DEL PUERTO CANYON **RESERVOIR**

Environmental Impact Report Volume V-Response to Comments on PRDEIR

SCH# 2019060254

Second Final Environmental Impact Report Volume V – Response to Comments on Partially Recirculated Draft EIR SCH# 2019060254

Figure 12-1 San Joaquin River Floodplain at the Del Puerto Creek Confluence

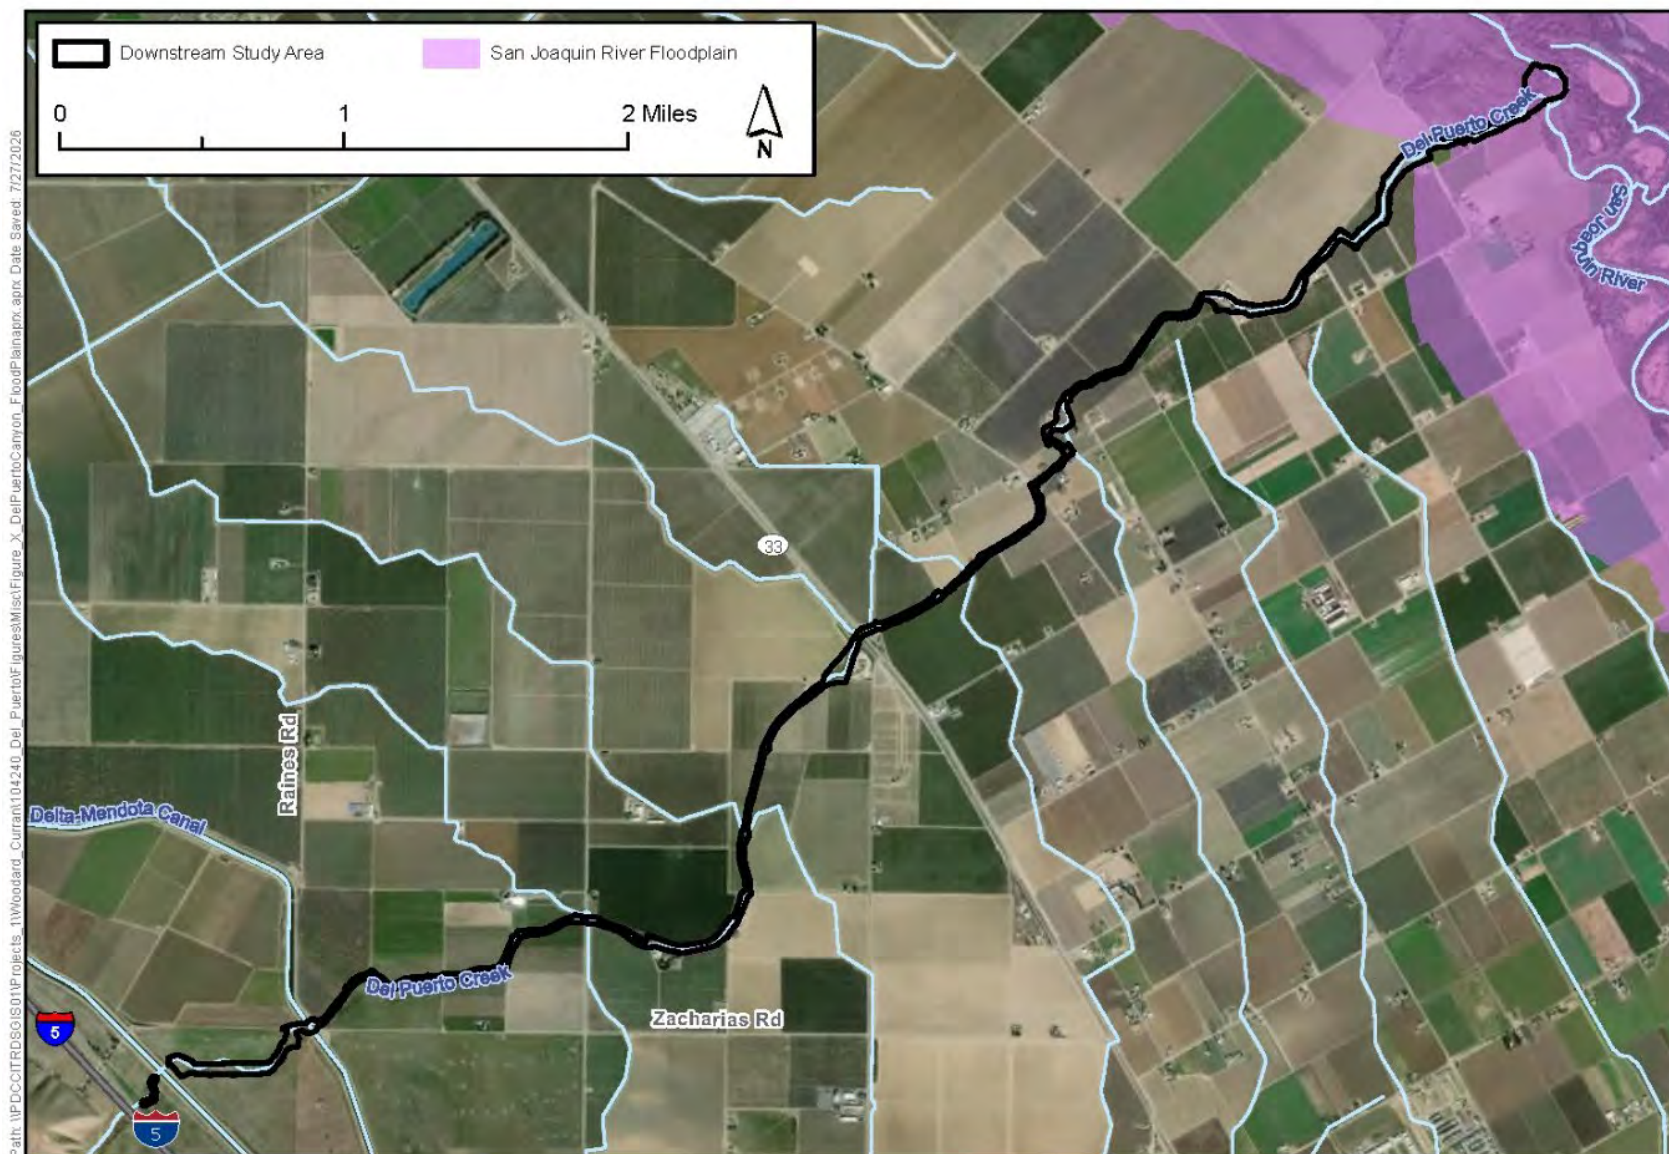
Comment Summary: Several commenters questioned how downstream ecological processes supporting downstream terrestrial resources would be retained despite reduced total flow volume.

Figure 12-1 illustrates the extent of the San Joaquin River floodplain (shown in purple) at its confluence with Del Puerto Creek. Near the confluence, the broader riparian corridor along Del Puerto Creek lies within the San Joaquin River floodplain. In contrast, the majority of Del Puerto Creek in the downstream study area is located outside of the San Joaquin River floodplain, and is characterized by a narrow, fragmented riparian corridor surrounded by intensive agricultural development and associated residences.

The Project would not materially alter the San Joaquin River setting. Appendix F estimates that Project-related changes in average monthly San Joaquin River flow at Vernalis would be less than one percent and would not appreciably change river or Delta flow conditions. Accordingly, the more persistent hydrologic conditions, developed riparian vegetation, and regional connectivity documented near the confluence would remain under Project conditions.

These sources would continue under Project conditions, but they would differ in timing, magnitude, duration, frequency, and location and would not replace natural runoff on a one-for-one basis. The post-Project hydrologic regime would therefore be altered from existing conditions. The analysis below considers how the reduction in natural runoff, together with the continuing releases and downstream water sources described above, would affect the ecological processes identified in Section A.

Figure 12-2: Foothill Yellow-legged Frog Proposed Critical Habitat

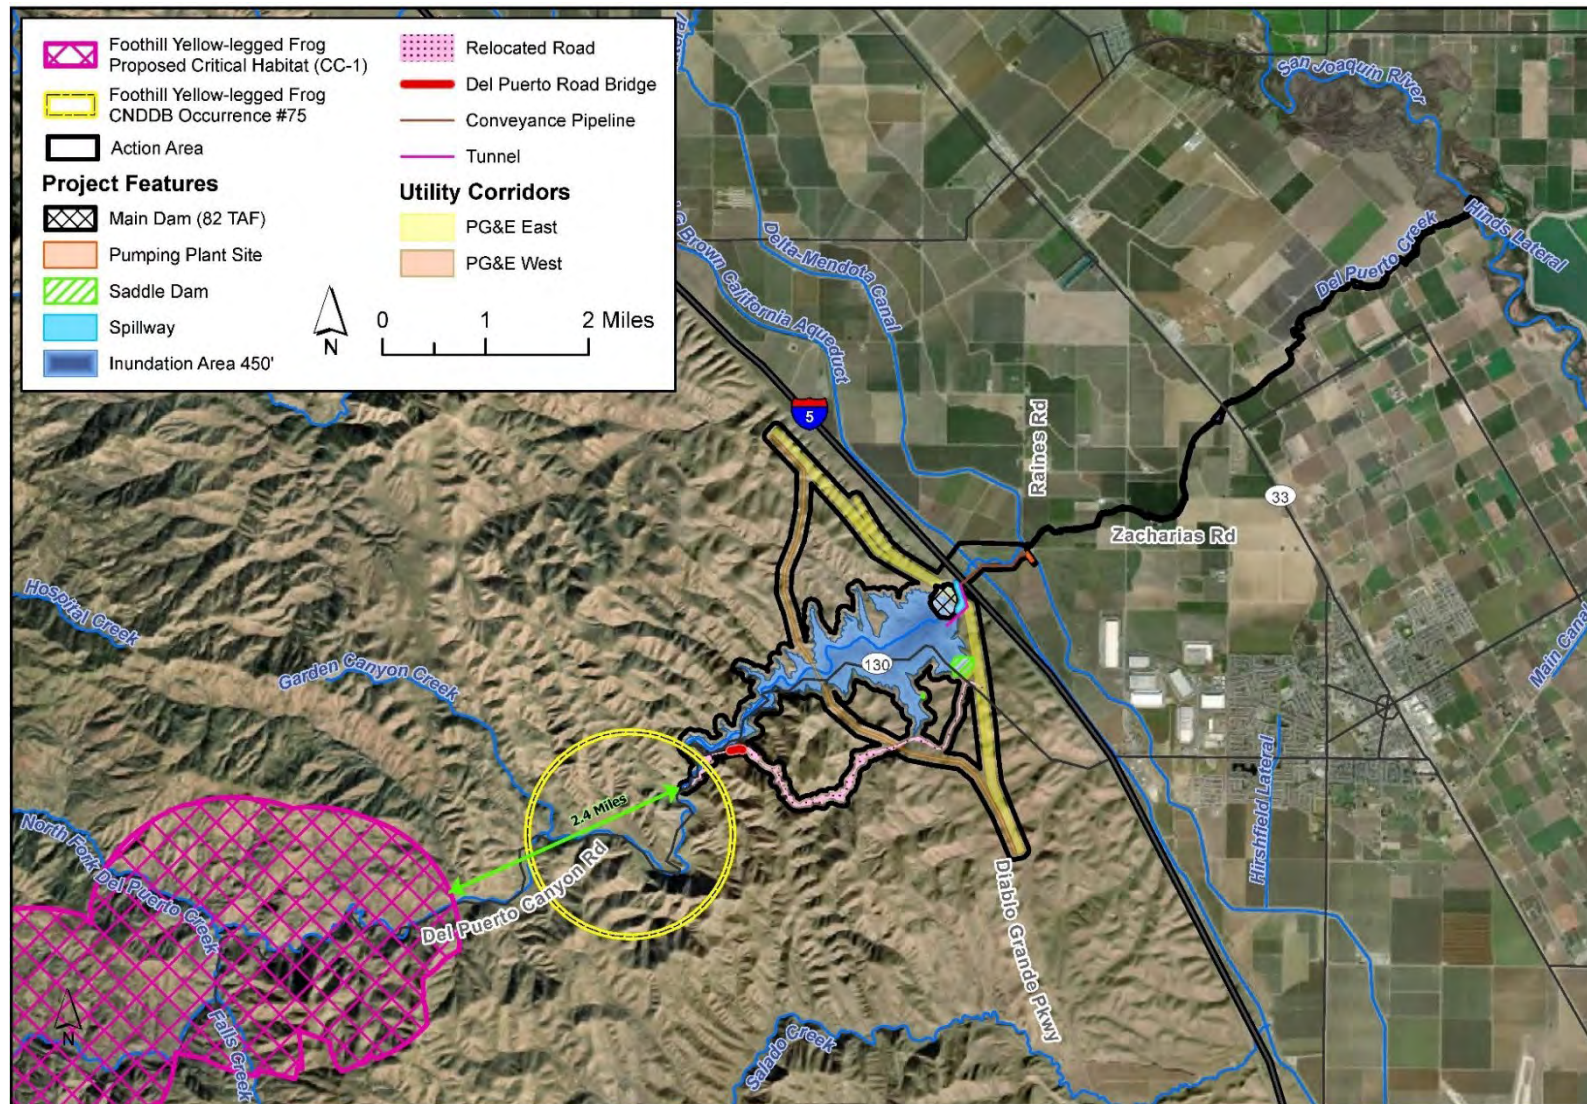
The comment also references the U.S. Fish and Wildlife Service's (USFWS) January 2025 proposed critical habitat designation for four distinct population segments of foothill yellow-legged frog. The proposal includes a Del Puerto Creek subunit in the upper watershed, predominantly within Santa Clara County. However, the proposed subunit is approximately 2.4 miles from the original study area and approximately 5 miles southwest of the downstream study area, as depicted in **Figure 12-1** below.

Nor does the proposed critical-habitat rule establish a new effect within downstream study area. A proposed critical-habitat designation identifies areas considered important to the species' conservation for purposes of the federal Endangered Species Act. It does not, by itself, establish species occupancy or suitable habitat at every location within or near a proposed unit. The PRDEIR's conclusions regarding foothill yellow-legged frog are based on the site-specific habitat conditions, occurrence records, and impact pathways present within the downstream study area.

Accordingly, the proposed critical habitat designation does not constitute significant new information requiring preparation of a subsequent or supplemental EIR or further recirculation. It does not reveal a new significant impact, a substantial increase in the severity of a previously disclosed impact, or a feasible mitigation measure or alternative that the District declined to adopt (See CEQA Guidelines, §§ 15162–15163, 15088.5, subd. (a)). At most, it provides updated regulatory and conservation context for species and habitat that the 2020 EIR already evaluated. It does not alter the 2020 Final EIR's or the PRDEIR's impact analyses or conclusions regarding potential impacts to foothill yellow-legged frog. The proposed rule does not demonstrate that the Project would cause an environmental impact different from or more severe than those previously identified.
